# Invitation for Comment on Queenstown Arterials Project (LP17)

**Invited Comment from the Hall Family Trust as owners of [REDACTED].**

Proposed Route – showing as being located on land at [REDACTED].

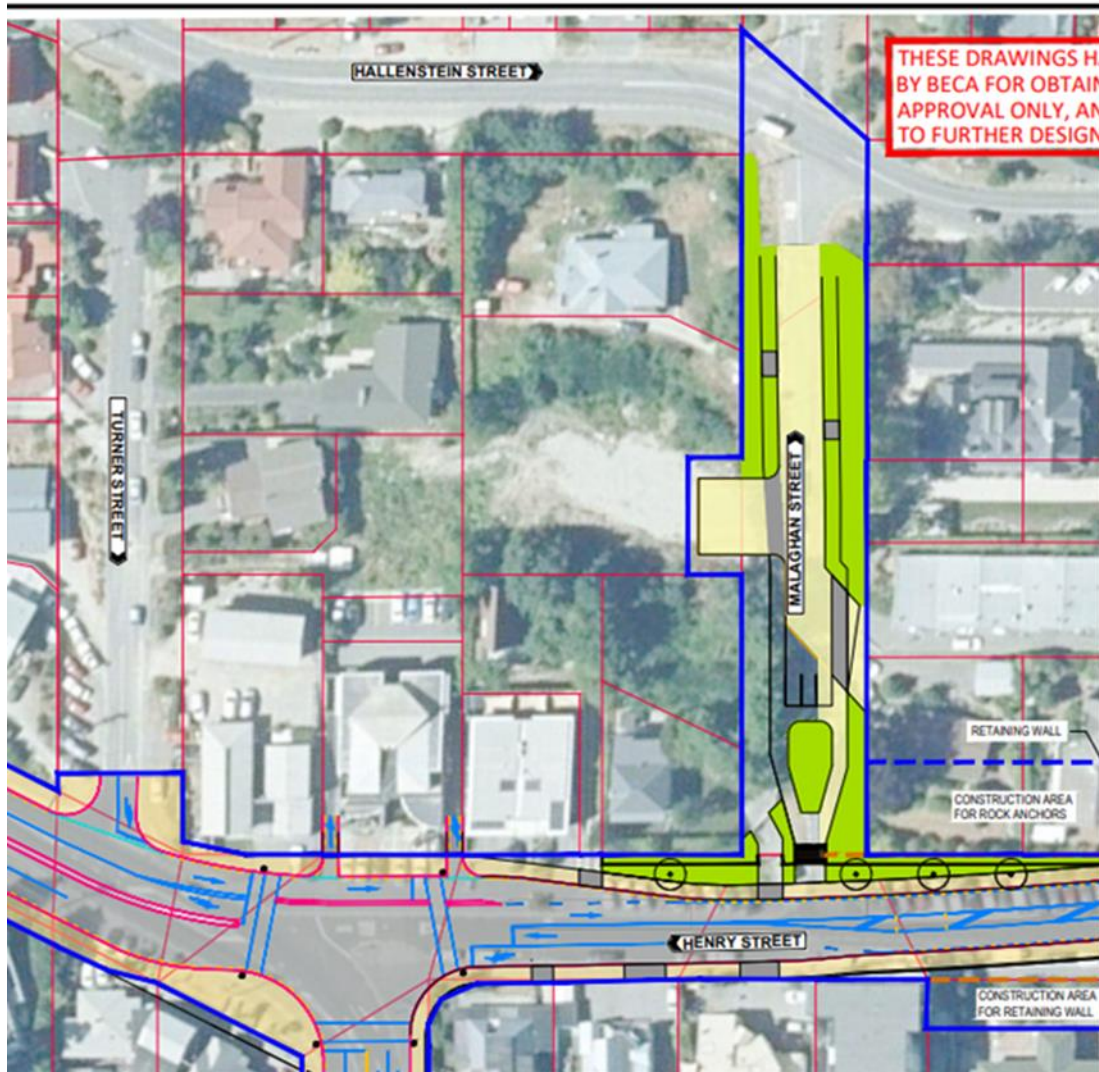
6. Both plans indicate that a portion of the Hall land (specifically included within [REDACTED]) will need to be acquired by the Council. The area of the required land is approximately 144m<sup>2</sup>, but may be more – the diagram shows a higher figure, but it is not sufficiently clear to understand how the land area required has been calculated.

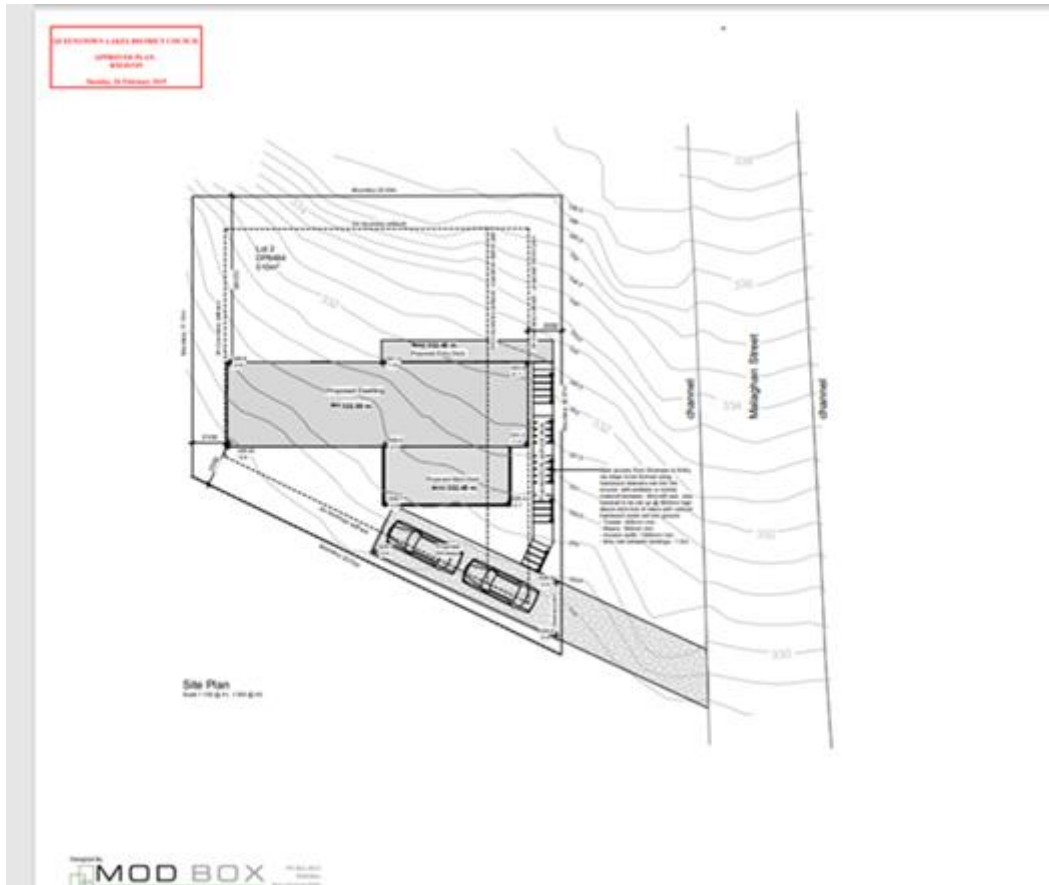
7. The Halls have several issues with the impact on their property for the proposed works to Malaghan Street.
8. It is understood that as part of the application, the Council is seeking to physically stop through traffic using Malaghan Street, between Hallenstein Street and Henry Street. Aside from assumed on-street parking and pedestrian access, Malaghan Street will be primarily used for vehicular access to the adjoining properties. It is assumed that the portion of the Hall land to be acquired will be to provide for a vehicle turn around area on Malaghan Street.
9. The aerial photos and maps used in the application are not current. The photograph is outdated for [REDACTED], in that it does not show the established residential dwelling that is established on this property. The site plan for established residential dwelling at [REDACTED] is below:

10. The physical works proposed for Malaghan Street as part of the Project do not take into account the established vehicle access to [REDACTED]. The property is a consented 365 holiday rental and onsite parking is required. Removal of vehicle access and onsite parking means that the property may require a further resource consent to comply with the district plan and that the attractiveness of the premises as a holiday accommodation is reduced.

11. It appears from the diagram provided that existing established access to this property will be removed and this will have a detrimental effect on the use and amenity of that land.

12. The consultation diagram also does not explain the use to which the land required for [REDACTED] will be used. It is not clear if this will be carriageway for traffic movements, or for vehicle parking. It is not possible to assess or comment on the impact of that on the Halls property.

14. No design provision for the arterial route has been made for safe alternative access to the land at [REDACTED].
15. The diagram provided for consultation does not make it clear whether the widening of the West side of Malaghan Street will occur wholly on road reserve. If not, further land acquisition from the Halls may be required.

- a) Redesign of arterial route (or vehicle access on [REDACTED]) to provide for safe vehicle access for residences at [REDACTED] or alternatively redesign/relocation of the existing vehicle access points; and
- b) Conditions imposed to require that any design and construction costs to create safe vehicle access by relocation/realignment of residential vehicle access on [REDACTED] are met by QLDC; and
- c) Compensation paid to the Halls for reduced amenity effects, and a reduction in the property value due to the development constraints resulting from the project.
